STAFF REPORT
COMMUNITY DEVELOPMENT DEPARTMENT

HEARING DATE: 11/3/2022
 TO: Planning & Zoning Commission
 FROM: Joe Dodson, Associate Planner
 208-884-5533
 SUBJECT: H-2022-0064
 Hadler Neighborhood
 LOCATION: Located at 7200 S. Locust Grove Road, approximately 1/2 mile south of the Locust Grove and Lake Hazel intersection on the east side of Locust Grove, in the N 1/2 of the SW 1/4 of Section 5, Township 2N, Range 1E.

Request for Annexation and Zoning of approximately 20.5 acres of land from RUT to the R-15 zoning district and a Preliminary Plat consisting of 145 building lots (52 single-family attached lots & 93 detached single-family lots) and 11 common lots on approximately 20 acres of land in the requested R-15 zoning district, by Laren Bailey, Conger Group.

C. Landscape Plans (date: 7/29/2022)

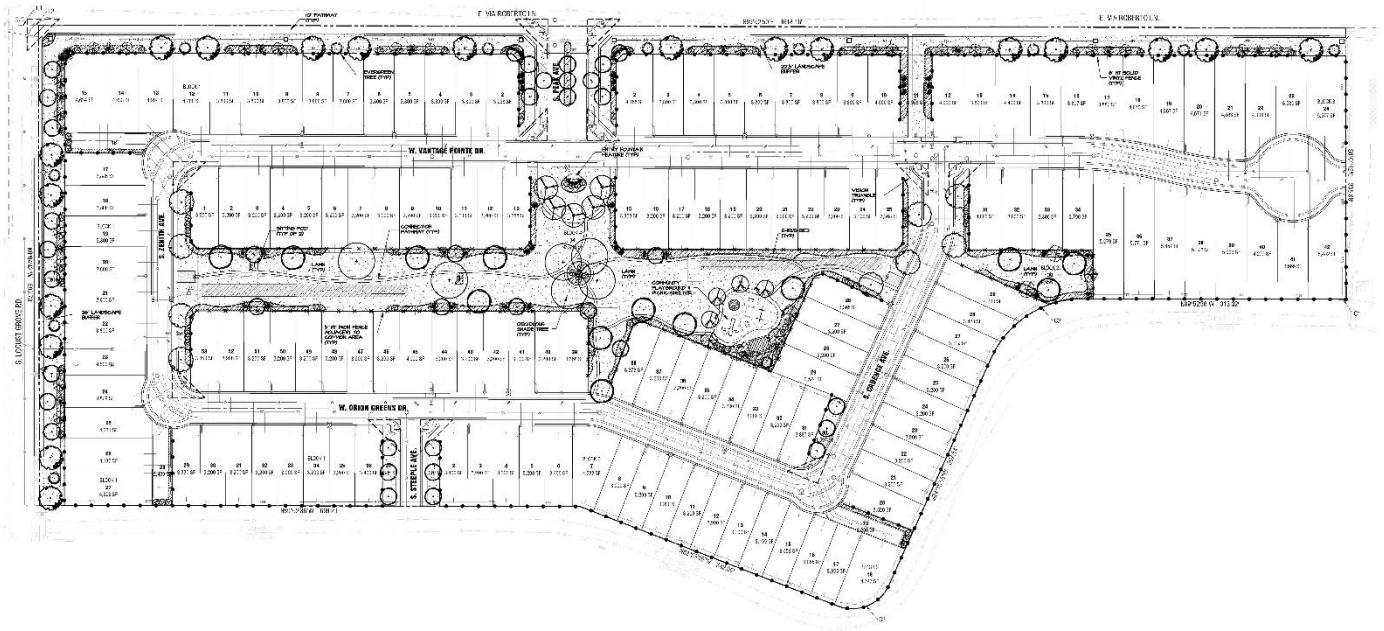
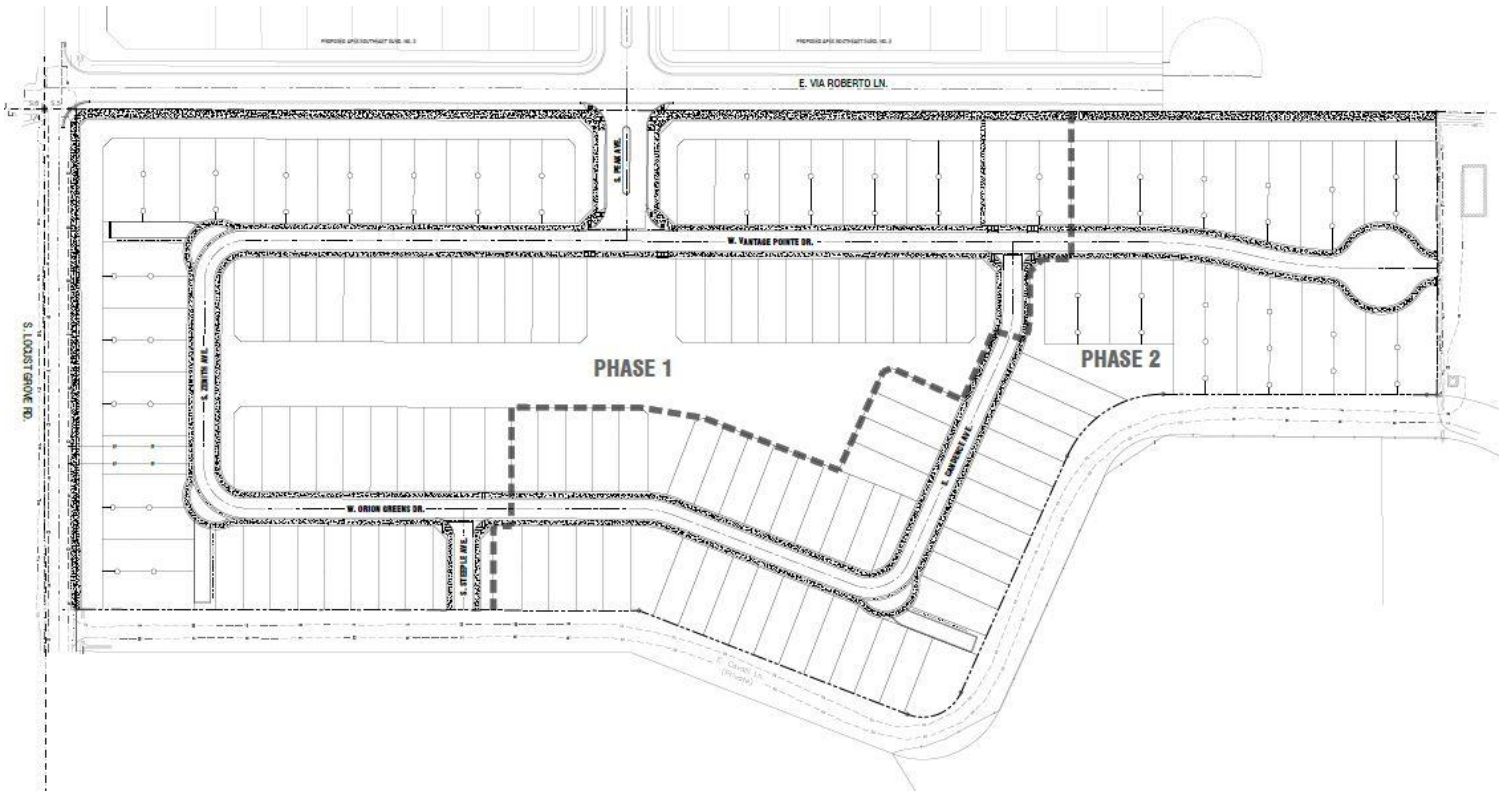
The pathway along Locust Grove appears to be attached to Locust Grove which does not comply with the UDC or Master Pathways Plan. So, the Applicant should revise the plat and landscape plan to depict this 10-foot pathway to be located within the required 25-foot buffer to Locust Grove and at least four (4) feet outside of the ultimate ROW to ensure the pathway remains detached.

The Applicant is showing a 25-foot wide common lot along Locust Grove that is a 22.5-foot wide common lot along Via Roberto consistent with code requirements. The landscape buffers are depicted with trees in excess of code and include landscape beds with shrubs and other vegetative ground cover, consistent with UDC 11-3B-7. Therefore, Staff finds the proposed street buffers comply with all UDC requirements. In addition, all open space areas are shown with trees, sod, and other landscaping in excess of minimum code requirements.

Staff recommends the Applicant provide evidence these buffers are enhanced beyond a sidewalk and trees. For example, boulders, additional vegetation, decorative elements, additional micro-pathways, etc. The burden of proof for the proposed common open space to qualify falls on the Applicant and not on Staff.

The centralized open space area is depicted with playground equipment, a gazebo with picnic benches, and multiple seating areas all connected to the surrounding local streets via 5-foot wide micro-pathways. Staff supports the design of the central open space area. As discussed within the Comprehensive Plan section above, the other common open space area (Lot 30, Block 2) is approximately 9,300 square feet in size and is tucked behind multiple building lots. Staff does not have concern with the size of this open space lot but is concerned with its location being a remnant piece and tucked away. Because of these concerns, Staff recommends the adjacent Lot 29, Block 2 be removed and added to the open space lot to increase the visibility of this open space area and include an additional micro-path connection to the southeast boundary.

3. The landscape plan included in Section VII.C, dated July 29, 2022, shall be revised as follows prior to submitting for Final Plat approval:
 - a. Revise the landscape plan to match the revisions made to the street section of Vantage Pointe Drive on the latest preliminary plat.

- b. Make the necessary revisions to the landscape plans to match the plat revisions noted above in VIII.A2.
 - c. Depict the 10-foot pathway along S. Locust Grove to be located within the required 25-foot street buffer and located at least four (4) feet outside of the ultimate ROW to ensure the pathway remains detached, consistent with UDC 11-3B-7C.1a.

F. Common Drive Exhibits:

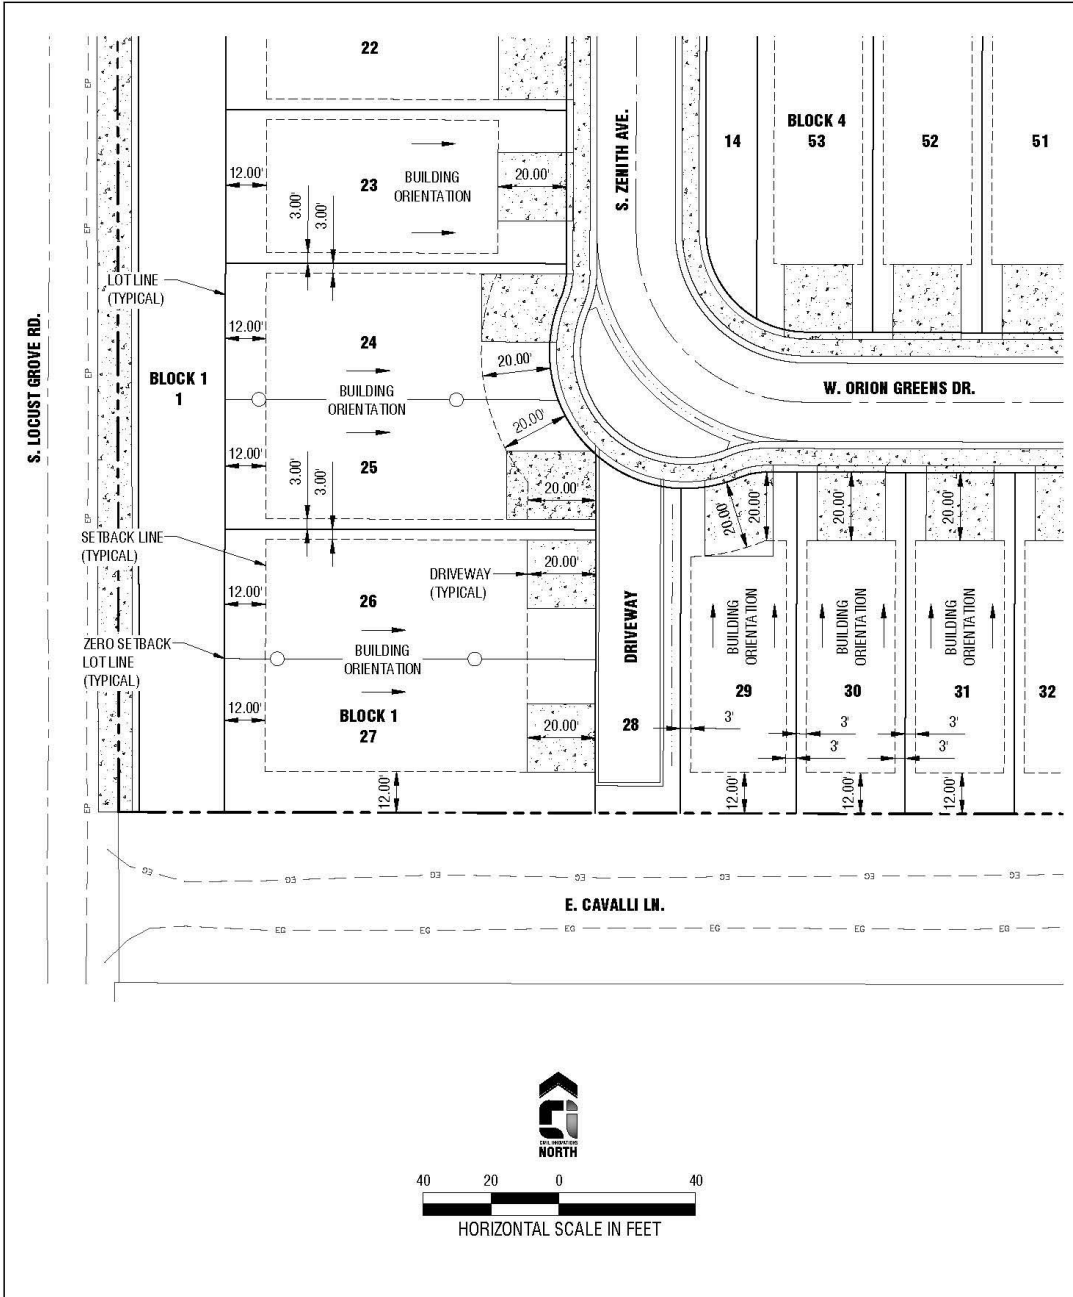
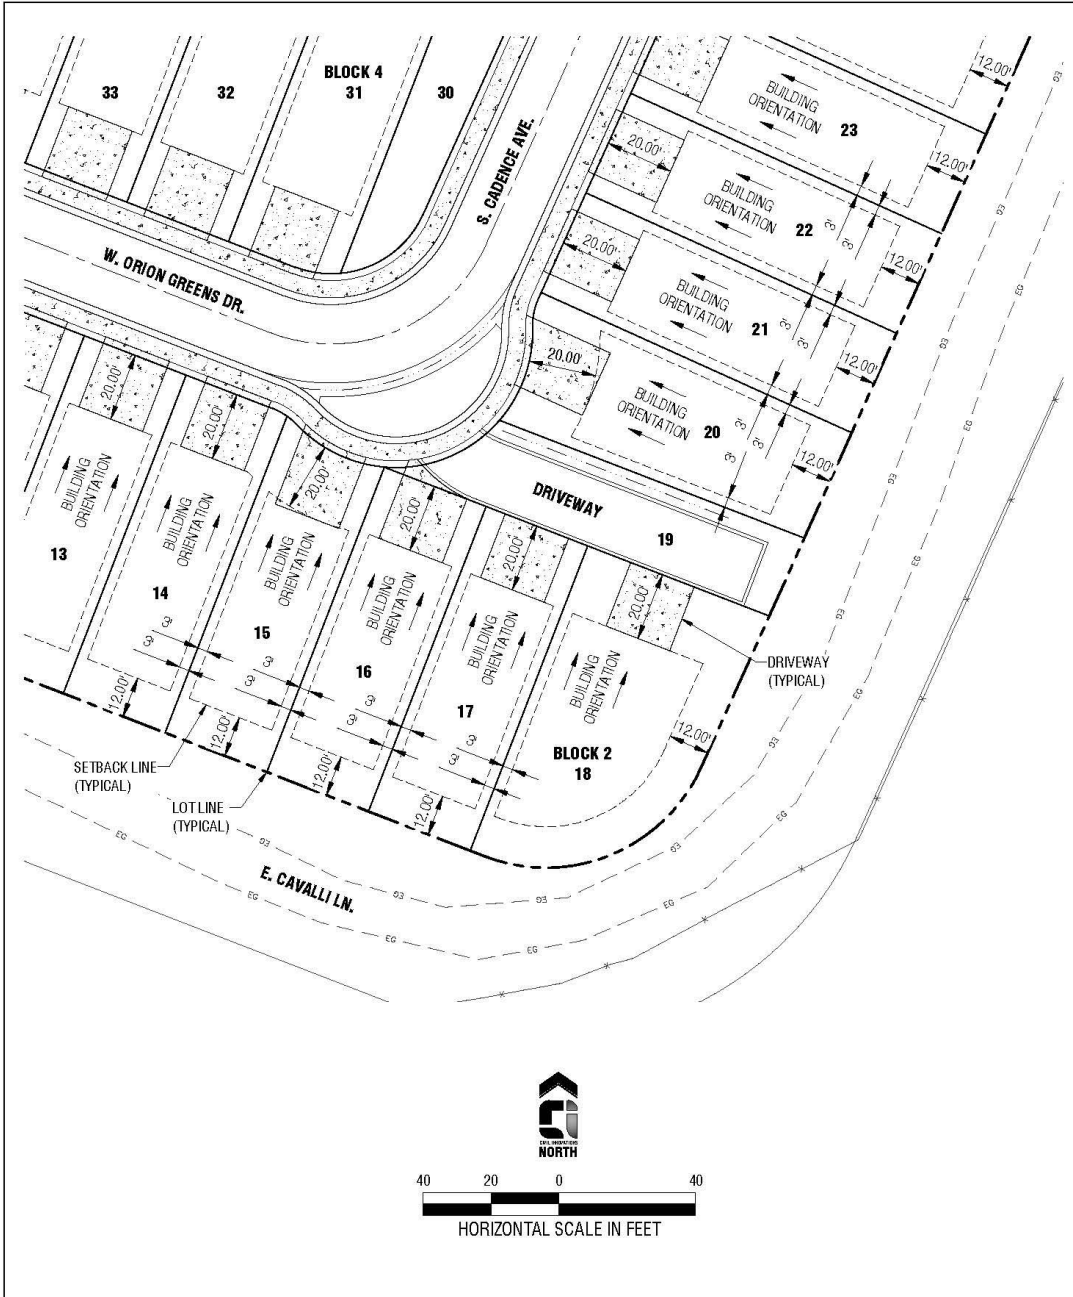
The three (3) proposed common drives depict 3 lots taking access from each of them and include at least 5 feet of landscaping adjacent to the abutting lot not taking access from the common drive. The proposed common drive design complies with UDC 11-6C-3D requirements.
